Subject: **PALO VERDE SOLAR I, LLC'S PETITION FOR AMENDMENT  
BLYTHE SOLAR POWER PROJECT  
DOCKET NO. (09-AFC-6C)**

# BLYTHE SOLAR POWER PROJECT

**AMENDMENT**  
**(09-AFC-6C)**

## **FIGURE 2-5**

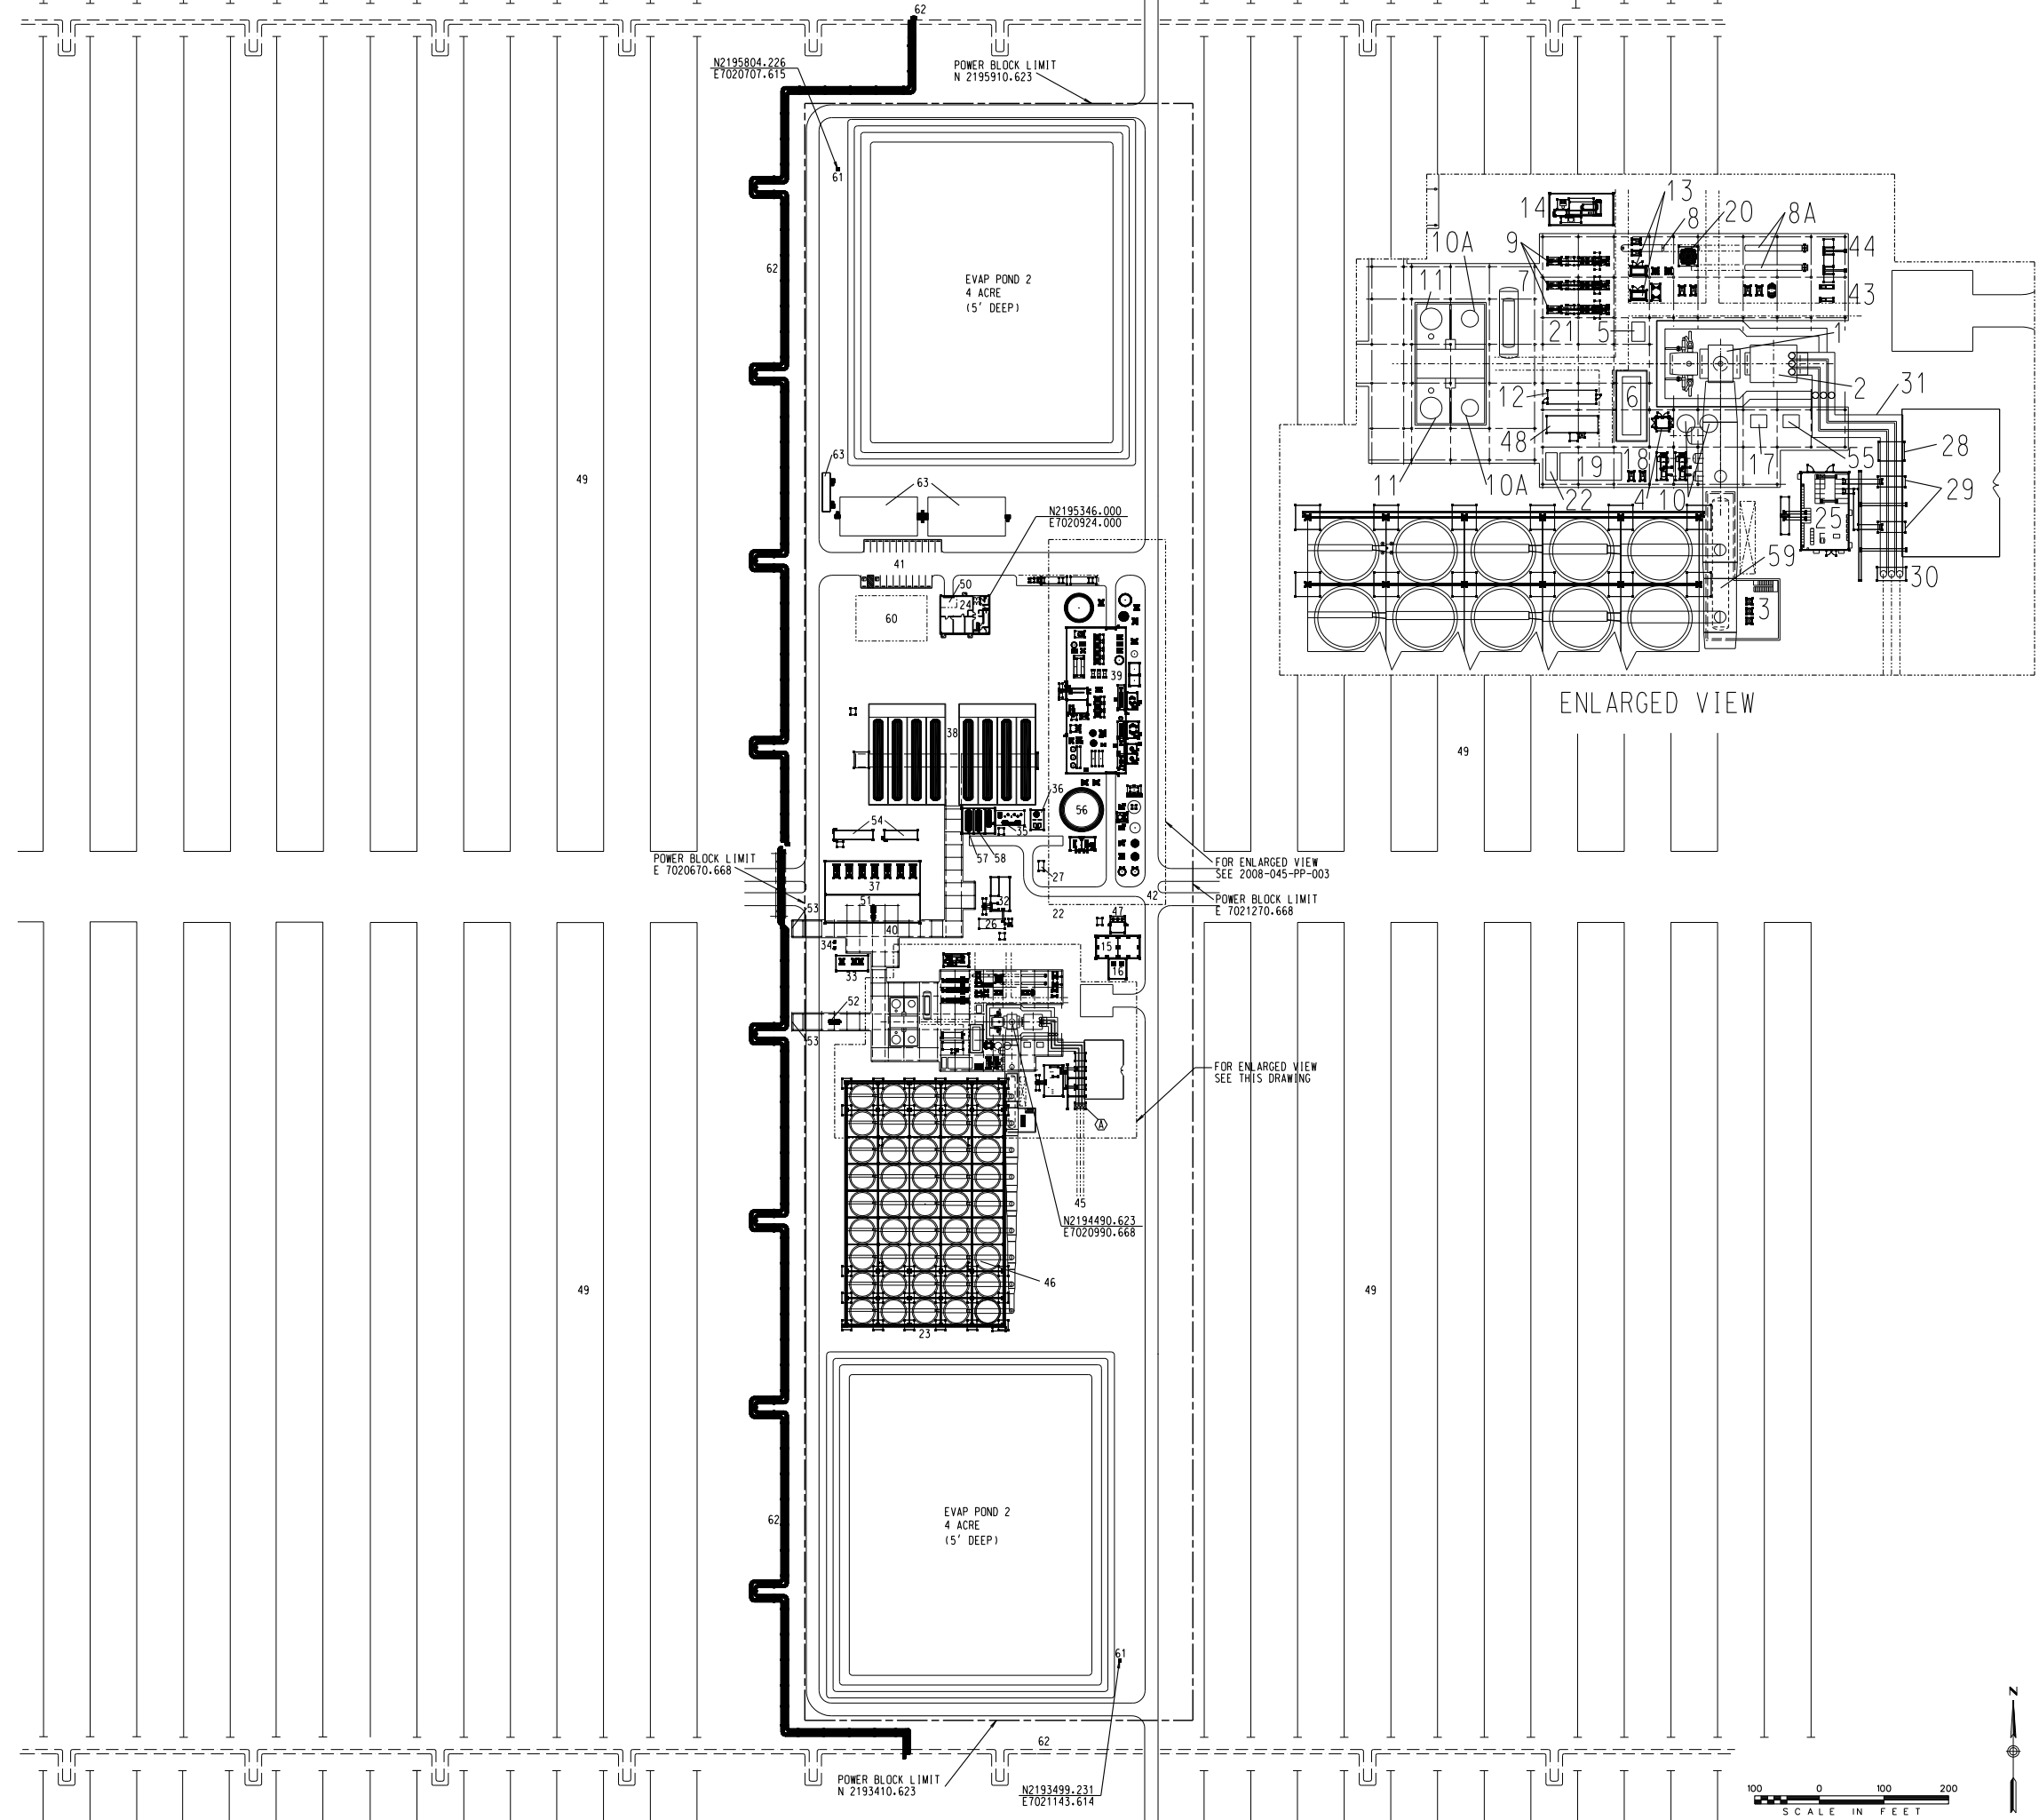
**Figure 2-5** is the Revised General Arrangement of Power Block Area and depicts all of the modifications that were made as part of final design work and rearrangement of equipment to accommodate the switch to the Siemens STG. The modifications are described below.

Since workshop, warehouse and administrative services have been consolidated into the buildings within the Shared Facilities Area, it was determined during the final design phase of the BSPP that size of the Control/Maintenance Building in power block for each unit could be decreased from approximately 12,000 square feet to approximately 4,500 square feet.

To accommodate the use of the Siemens STG the following components were simply rearranged within the Power Block Area:

- HTF Expansion Tanks,
- HTF Pumps,
- VFD Controls
- HTF Electrical Enclosure
- Electrical Equipment including the Isophase Bus Duct, Generator Circuit Breaker, Auxiliary Transformers and the Power Control Center
- Condensate Drains located in the LP heaters area

As part of the final design the Ullage/Regeneration system and the Nitrogen System were relocated near the southeast corner of the Expansion tanks.
